Access Compliance Report

Public Rights-of-Way

(Curb Ramps)

Intersection ID: 3120	Main Street: DAUPHINE_DR	Cross Street: WALDEN_RIDGE_DR	Location:	E
ADA ID: 1962D01DFDDF	Ramp Type: Perp	Initial Pass/Fail: Fail	Overall Compliance: No	Severity Score: 22.5
Codes/Mitigation Info/Possible Solution		Field Measurements/Component Compliance

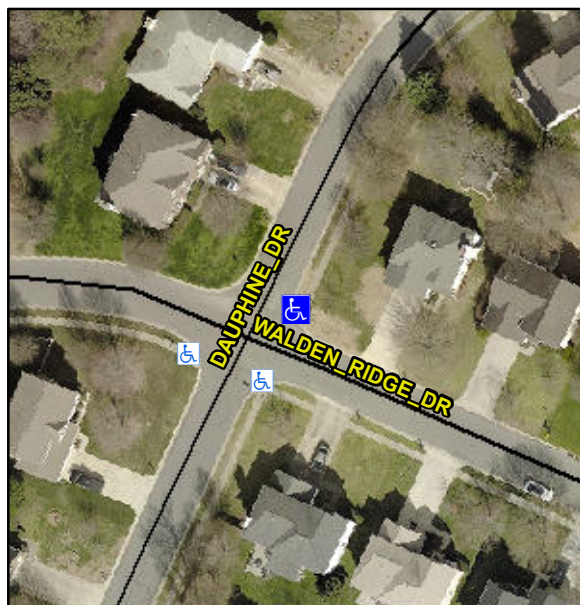
Not Found, R304.5.1, R304.2.2, R304.5.3

Compliance	Description	Data	Compliance	Description	Data
N/A	Ramp Length (in)	29.0	No	Ramp Slope (%)	10.3
No	Ramp Width (in)	46.0	No	Ramp XSlope (%)	4.5
N/A	Flare Type LT	N/A	N/A	Flare Type RT	N/A
N/A	Flare Slope LT (%)	N/A	N/A	Flare Slope RT (%)	N/A
N/A	Flare Traversable LT?	N/A	N/A	Flare Traversable RT?	N/A
N/A	Landing Length (in)	N/A	N/A	DWS Provided?	N/A
N/A	Landing Width (in)	N/A	N/A	DWS Contrast?	N/A
N/A	Landing Slope (%)	N/A	N/A	DWS Length (in)	N/A
N/A	Landing X Slope (%)	N/A	N/A	DWS Full Width?	N/A
N/A	Landing Curb? (Y/N)	N/A	N/A	DWS Offset (in)	N/A
N/A	Shared Landing?	N/A			
N/A	Gutter Ponding?	N/A	N/A	Gutter Slope (%)	N/A
N/A	Gutter Lip Ht (in)	N/A	N/A	Gutter X Slope (%)	N/A
N/A	Painted X Walk1?	No	N/A	Painted X Walk2?	N/A
	X Walk 1 Direction	To SW		X Walk 2 Direction	N/A
N/A	X Walk 1 Width (in)	N/A	N/A	X Walk 2 Width (in)	N/A
	X Walk 1 Slope (%)	0.6		X Walk 2 Slope (%)	N/A
	X Walk 1 X Slope (%)	3.4		X Walk 2 X Slope (%)	N/A

Remove & Replace Entire Ramp.
